This is an ODOT let project. The project name in the plans shall match the project name in Ellis:
BUT GMR Trail Middletown-Monroe

GREAT MIAMI RIVER TRAIL

COVER SHEET	P.1
SCHEMATIC PLAN	P.2
TYPICAL SECTIONS	P.3
GENERAL NOTES	P.4
GENERAL SUMMARY	P.5
PLAN AND PROFILE	P.6-P.24
CROSS SECTIONS	P.25-P.69

119064

P.56 69

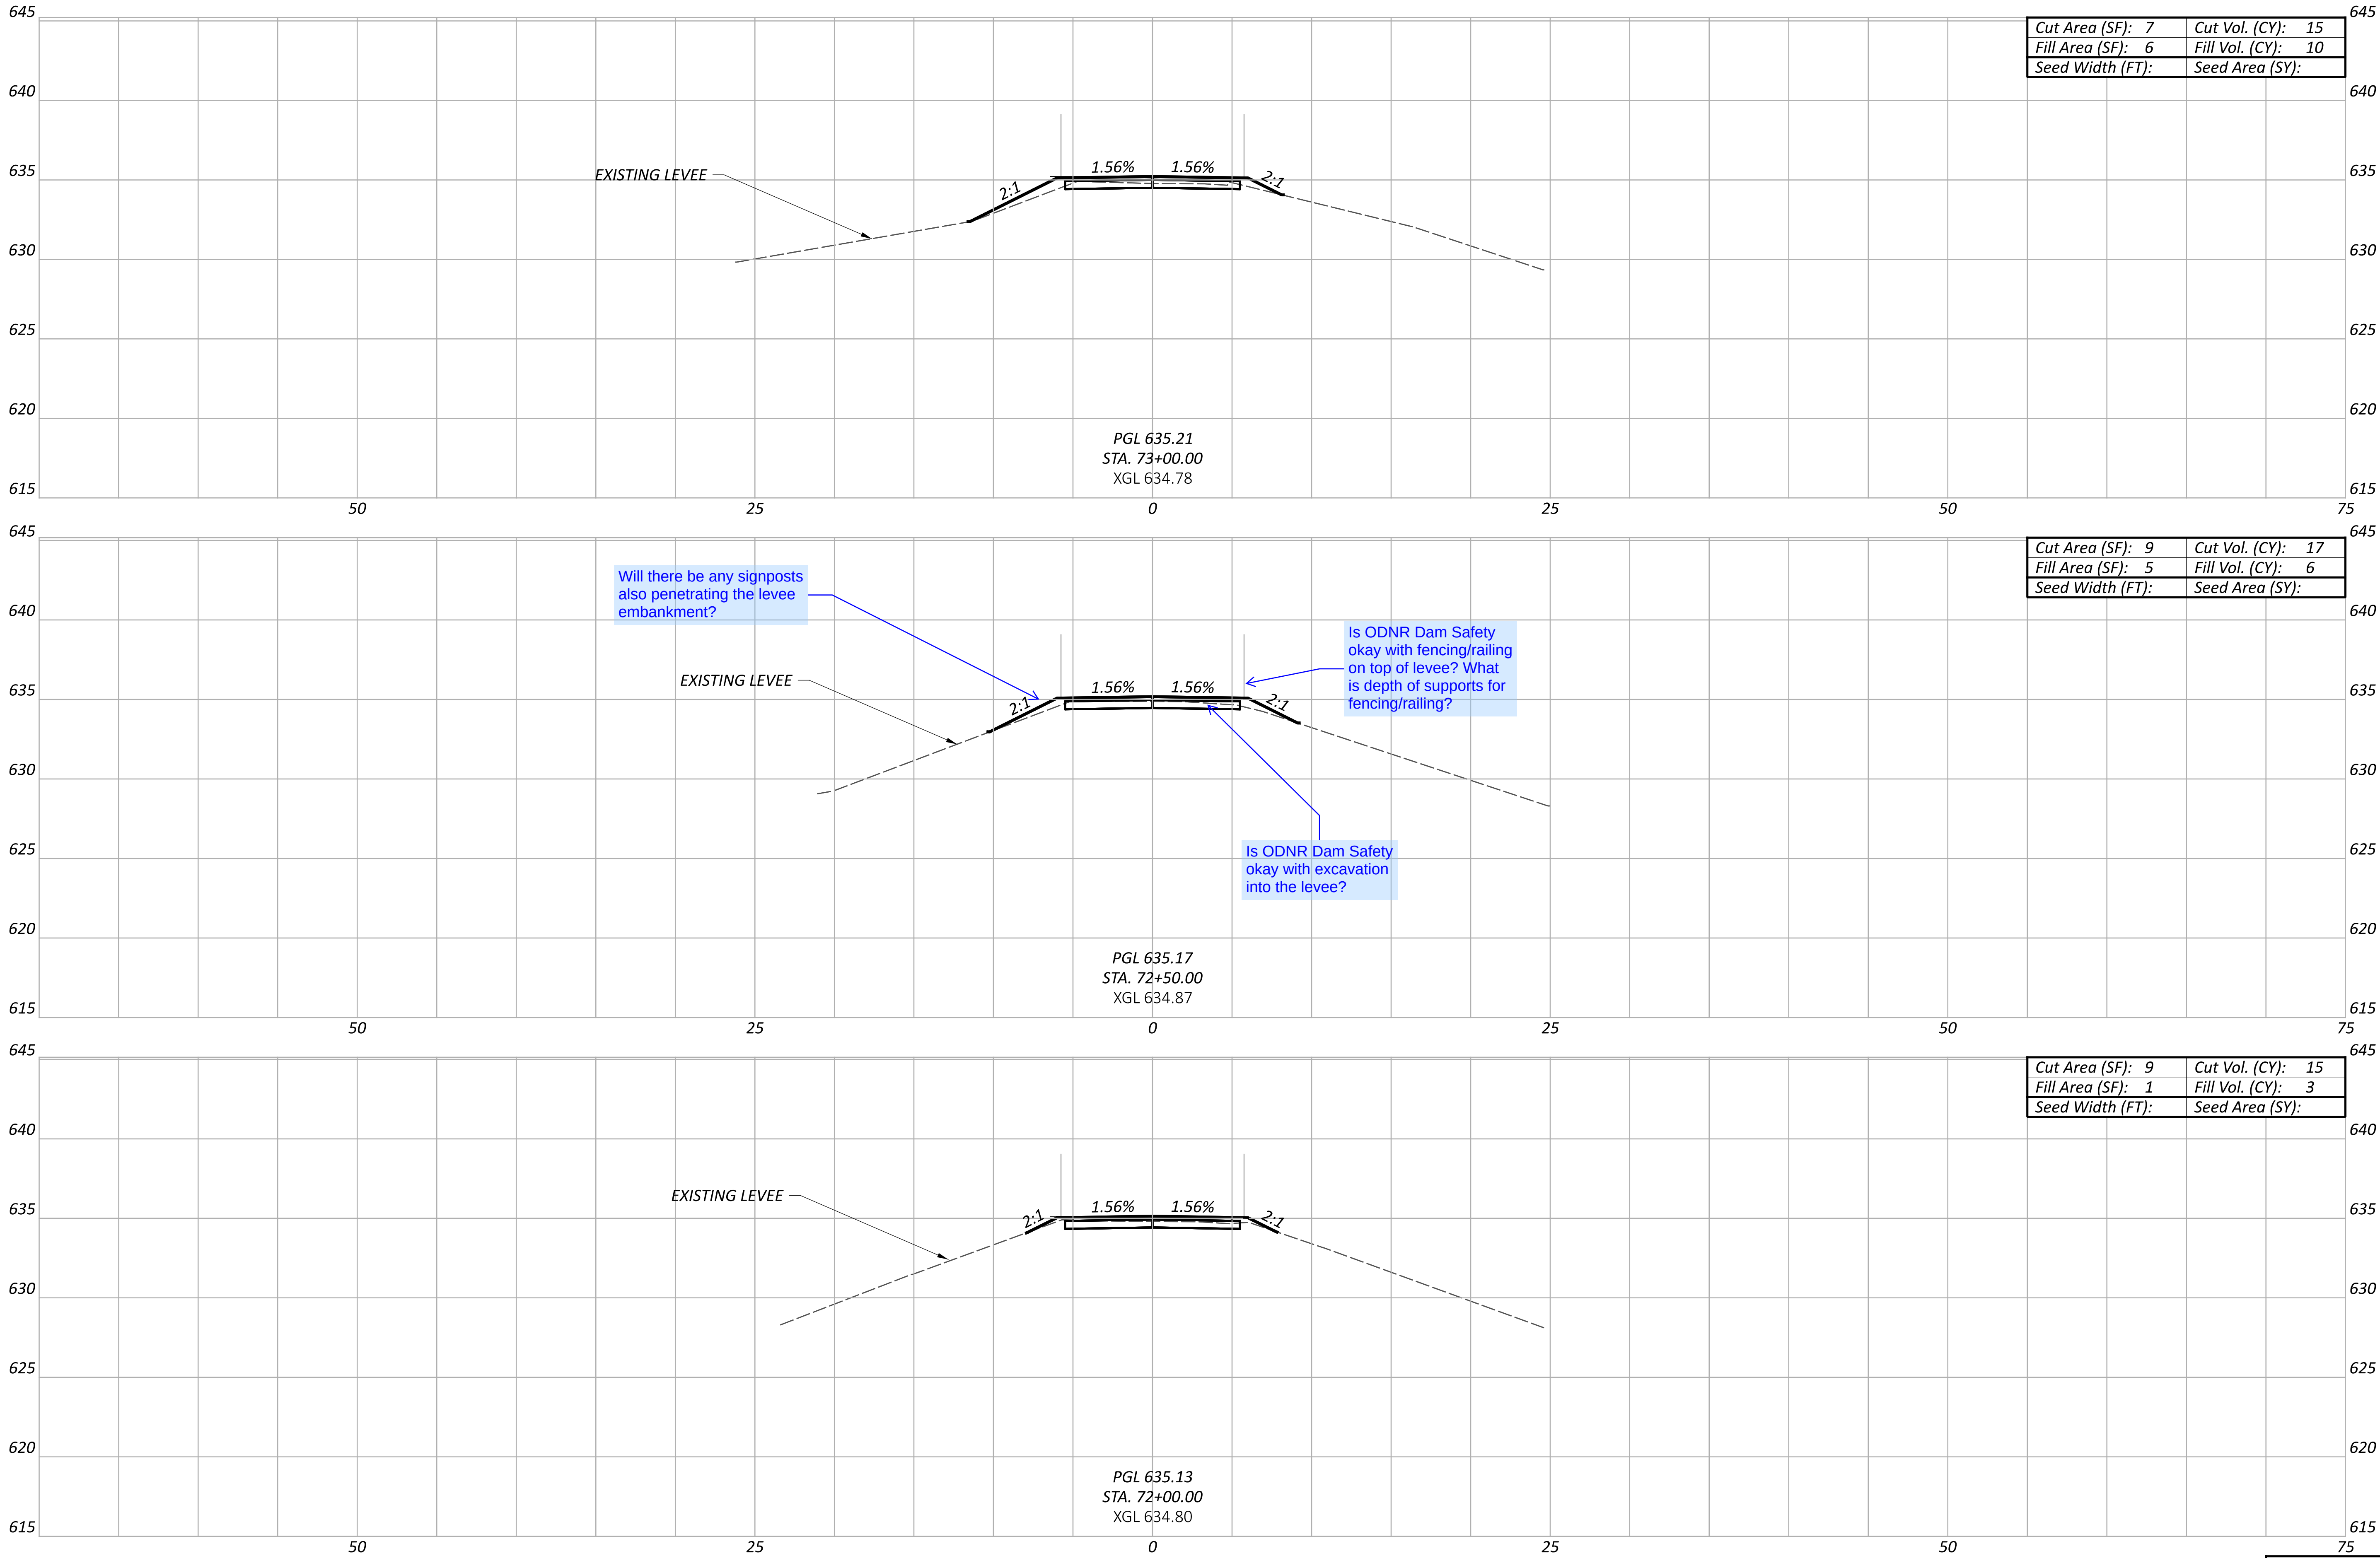
will need details showing how the railing and the wall are spaced to avoid conflicts

If walls exceeds 4 ft design will be required including global stability.

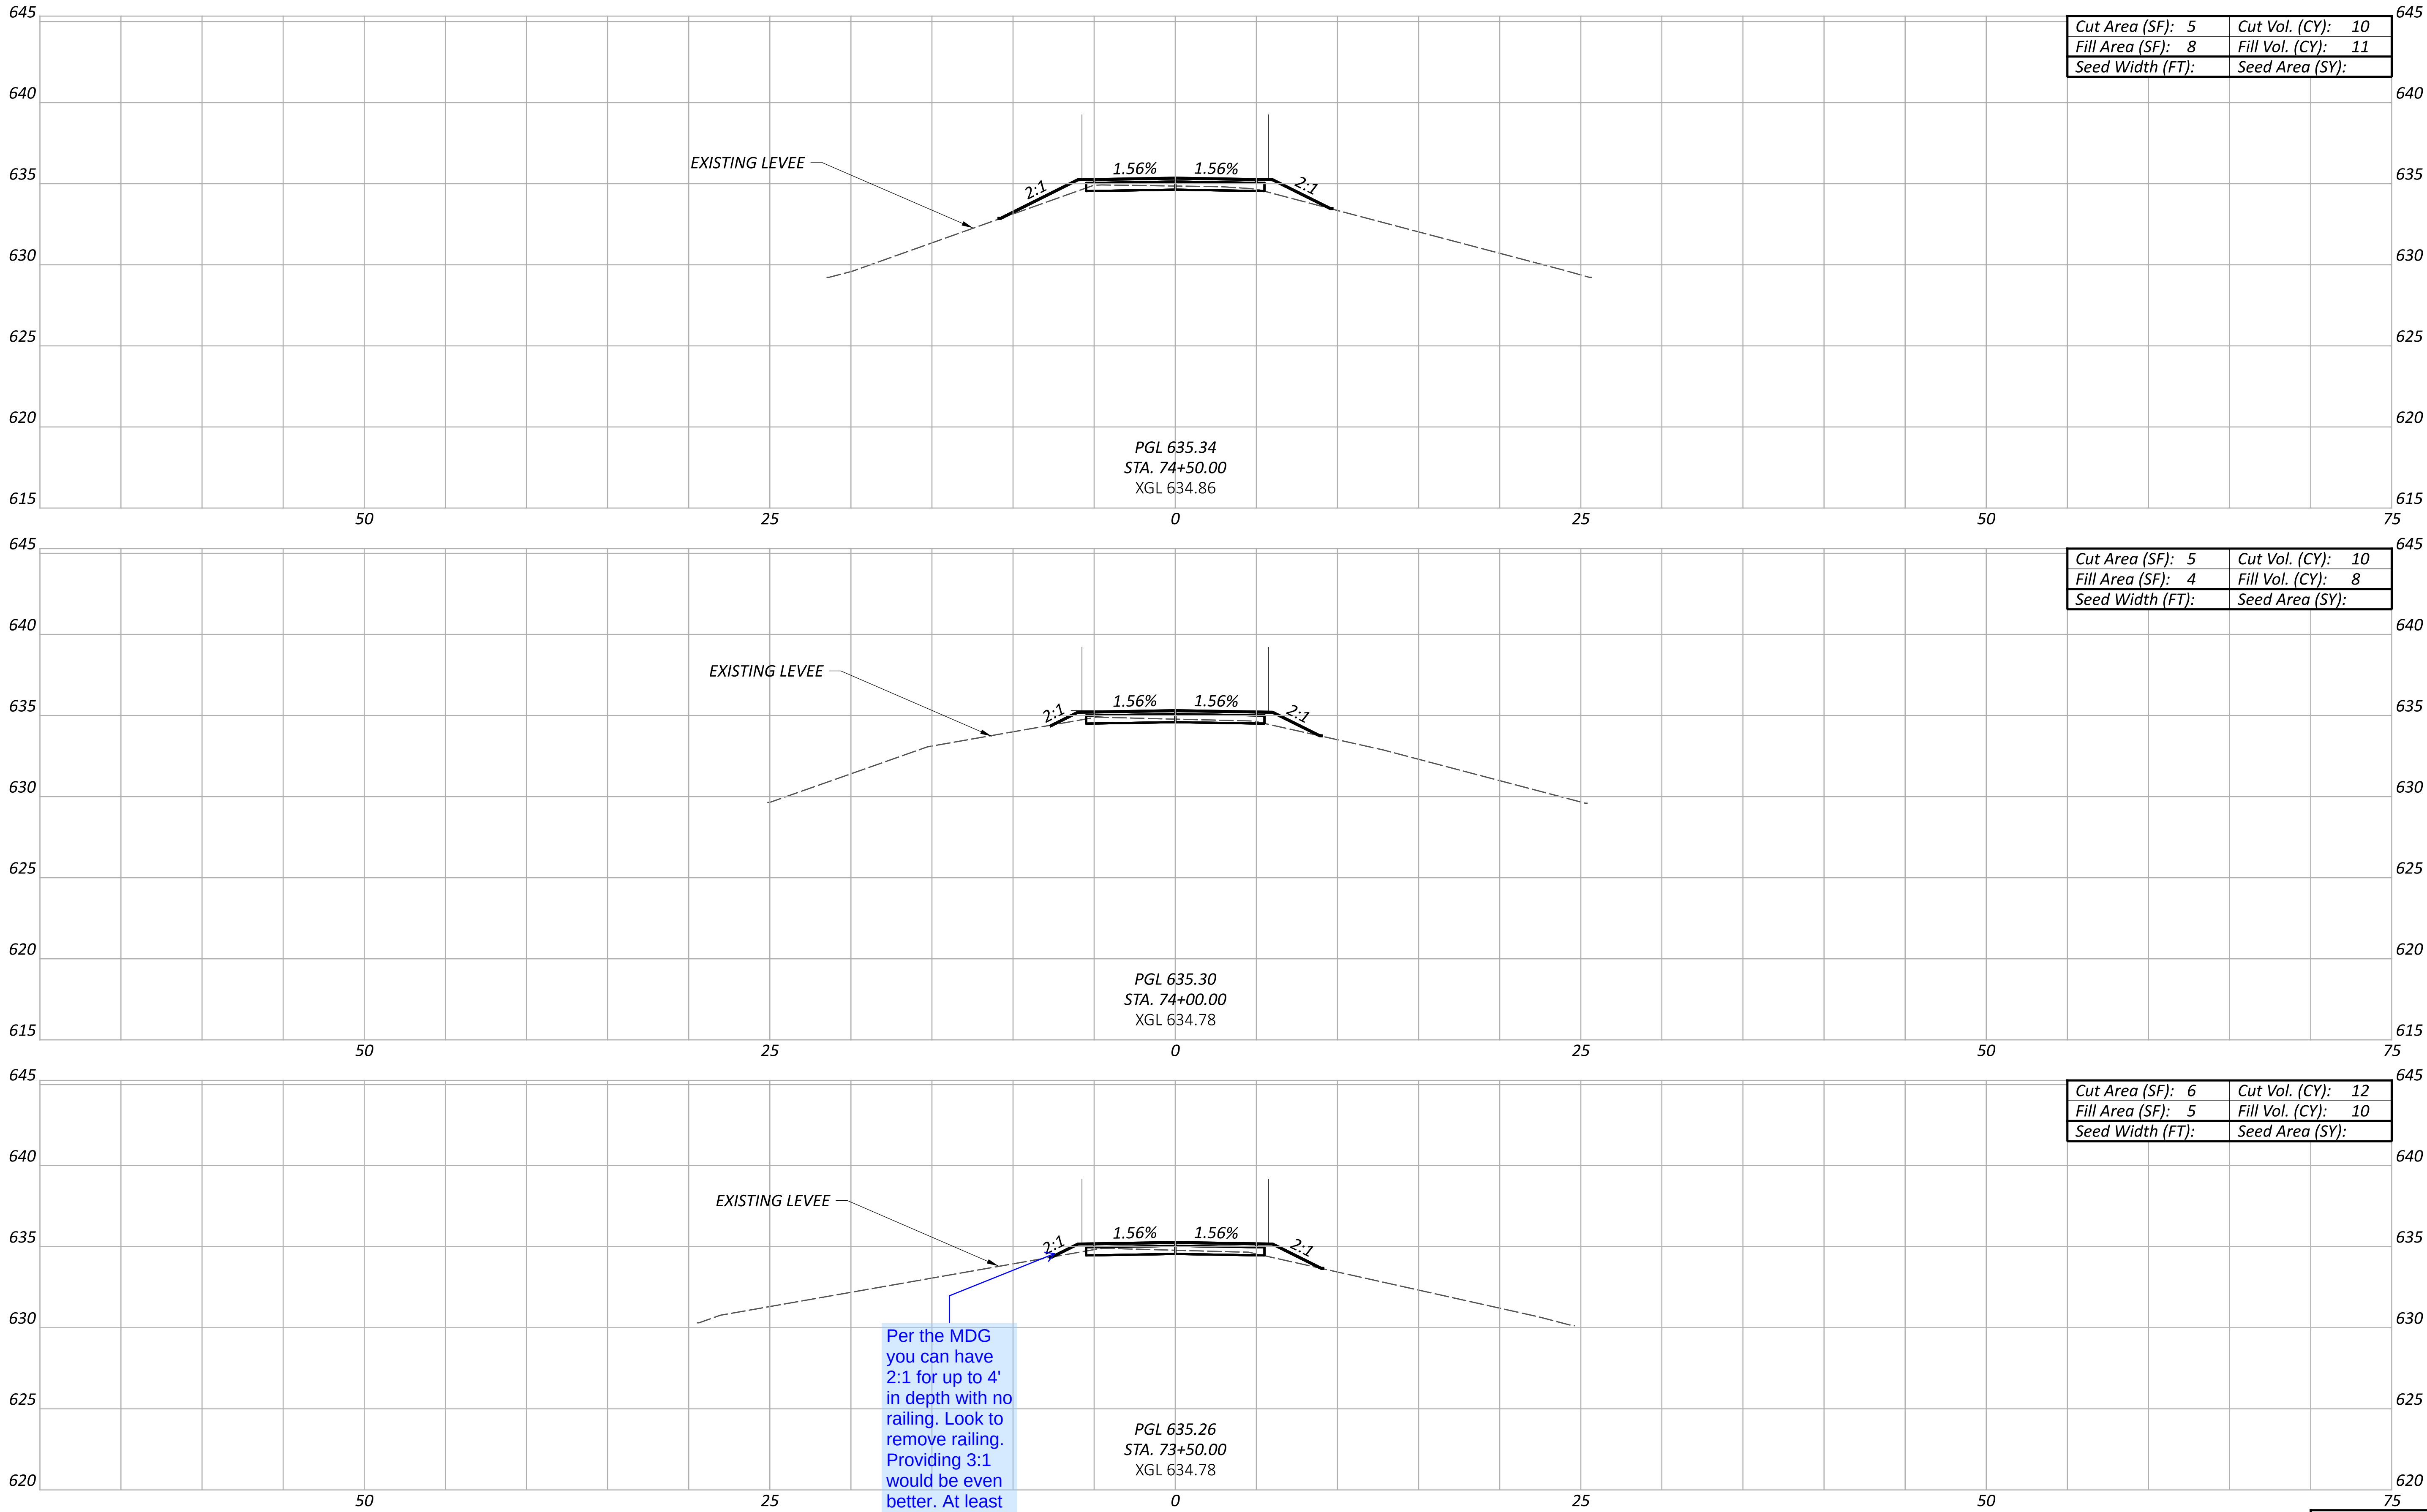
Per the MDG you can have 2:1 for up to 4' in depth with no railing. Look to remove railing. Providing 3:1 would be even better. At least on the inside of curves where railing blocks sight lines.
